# Comment on "Derivation of a sigmoid generalized complementary function for evaporation with physical constraints" by S. Han and F. Tian

## COMMENT

10.1029/2018WR023502

This article is a comment on Han and Tian (2018), <https://doi.org/10.1029/2017WR021755>.

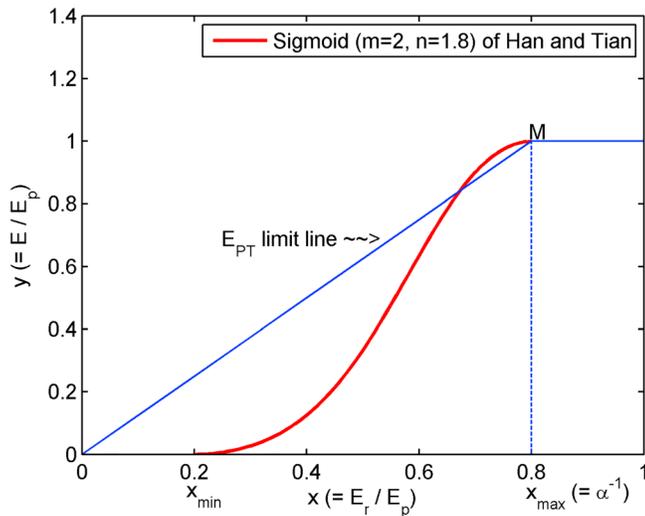
The upper boundary condition (BC) proposed by Han and Tian, namely, that  $dy/dx = 0$  at  $y = 1$ , creates a hard to interpret physical situation. Due to the flat upper part of their CR curve,  $E$  remains equal to  $E_p$  for a while as the  $x$  value starts to decrease from its  $x_{max}$  value. In reality, however, with the region drying out,  $E$  can be expected to decrease from its maximum value of  $E_p = E_p^{wet}$ , attained under regionally wet conditions. The  $E = E_p$  condition for  $x$  close to  $x_{max}$  (the result of the flat upper portion of Han and Tian’s curve) entails that  $E$  increases in the beginning of the drying process under a constant  $E_r$  term, since the  $E_a$  term of  $E_p$  must increase to be able to move  $x$  from its maximum value of  $x_{max}$ . As a result, the model-derived  $E$  not only increases with the drying out of the environment but one also ends up with a  $y$  value above the  $E_{PT}$  limit line ( $=\alpha x$ ), which thus loses its constraining property. Note that with  $x_{max} = \alpha^{-1}$ , point  $M$  of the  $E_{PT}$  line in Figure 1 of Han and Tian (which corresponds to  $\alpha = 1.26$  in their figure) moves right horizontally, to be situated above  $x_{max}$ , and by doing so crosses the solid red line of the sigmoid function to terminate on it (see Figure 1 below).

Let us see now how the authors arrived at their BC of (i)  $dy/dx = 0$  at  $y = 1$ . From partial derivatives of the  $E/E_p = f(E_r/E_p)$  CR equation with respect to  $E_r$  and  $E_a$ , Han and Tian correctly obtained two solutions, (i) and (ii)  $\partial E_a / \partial E_r |_{y=1} = \alpha - 1$ , here written with the  $x_{max} = \alpha^{-1}$  substitution. One can also obtain solution (ii) by applying the derivation with respect to  $E_r$  directly on  $E_a^{min} = (\alpha - 1) E_r$  and additionally assuming that  $\alpha$

is independent of  $E_r$ . However, they discard solution (ii) by saying that  $\alpha$  must also depend on  $E_r$ . Such a direct dependence, however, has not been shown in the literature, even though air temperature (among other variables) may be an influencing factor on the value of  $\alpha$ , as Han and Tian correctly quote.

So instead of only (i), (ii) may also be a solution to their system of equations, which means, at the very least, that there exists another solution beside  $dy/dx = 0$  at  $y = 1$ . In fact, due to the physical controversies this latter solution presents, one must conclude that there is only one physically interpretable solution, and that is solution (ii). Solution (ii) however does not restrict the value of  $dy/dx$  to zero at  $y = 1$ , thus a  $dy/dx$  value of  $\alpha$  at  $y = 1$ , first proposed by Brutsaert (2015), is perfectly acceptable, as it fully avoids the physical contradictions raised by the  $dy/dx = 0$  value of Han and Tian.
